Technical Service Bulletin

Transaction No.: **2081184/1**

97 Engine warning lamp lights up, event memory U366500, P2D8800 or P2D8B00 logged in thermal management control unit

Figure 1. Earth point 642 is circled in yellow.

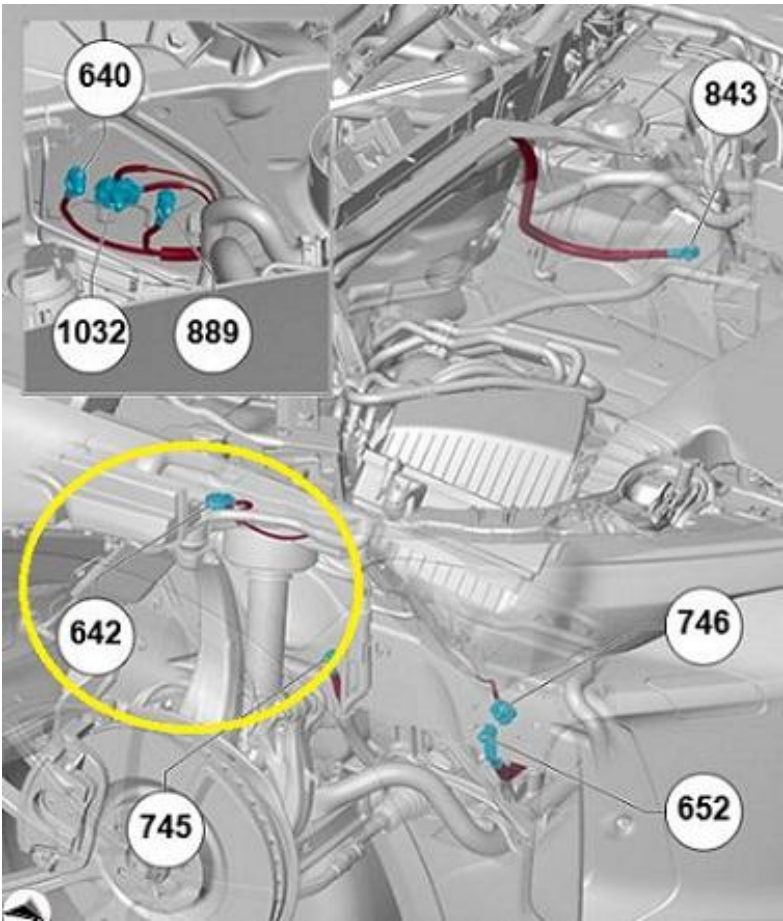
On vehicles manufactured within a specific period, the earth connection at earth point 642 for electrically controlled fan was fitted incorrectly.

Check earth point 642 for electronically controlled fan (front right) for damage or other issues (refer to yellow oval in image).
